Office Action Summary

10/599,206

GRAZZIOTIN, FERNANDO
ALBERTO

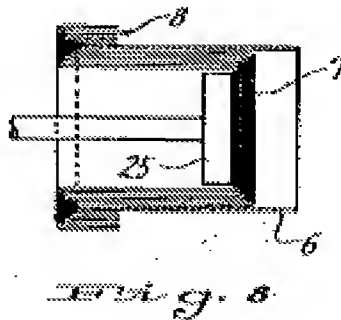
11. In re Claims 1, Nestler (Figure 8 shown above) teaches a bag characterized by:

- **Being composed of multiple detachable bags forming a set (5) in which each bag is within the subsequent ones** (Column 2, Lines 26-30 and Figure 8), **except for the external bag** (the external bag in the stack is in contact with the cardboard support 6 in Figure 8, and this not nested inside another bag); **and**

- **having an opening for the removal of the inner bags** (Column 2, Lines 57-61), **which will be successively detached from the first** (the first bag is being taken as the external bag, such that each bag is detached from the stack until the first or external bag remains), **as used**.

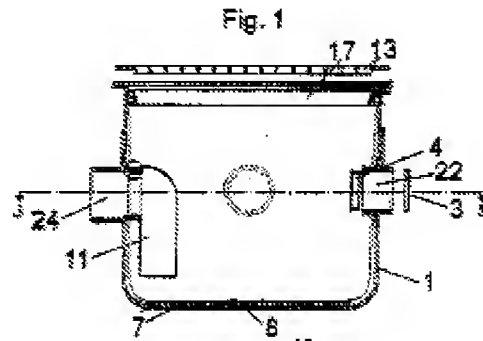
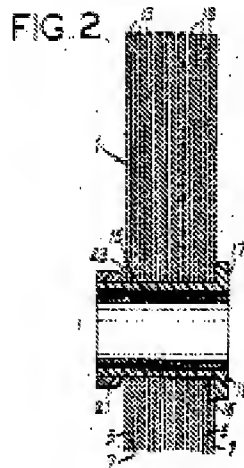
16. White (Figure 2 shown above) teaches a stack of bags (1) with a bushing (17) extending through a circular opening in the sheets of material comprising individual bags (Figure 2). Grazziotin (Figure 1 shown above) teaches a removable liner (7) for a tank (1) with both an inlet (22) and an outlet (24). It would have been obvious to one of ordinary skill in the art at the time the invention was made to provide the nested bags as taught by Nestler with a circular opening and bushing as taught by White to help ensure that nested bags remained in the nested configuration. Further the combination of Nestler/White is capable of being used in an application like the one taught by Grazziotin in which the bushings are attached to an inlet and outlet.
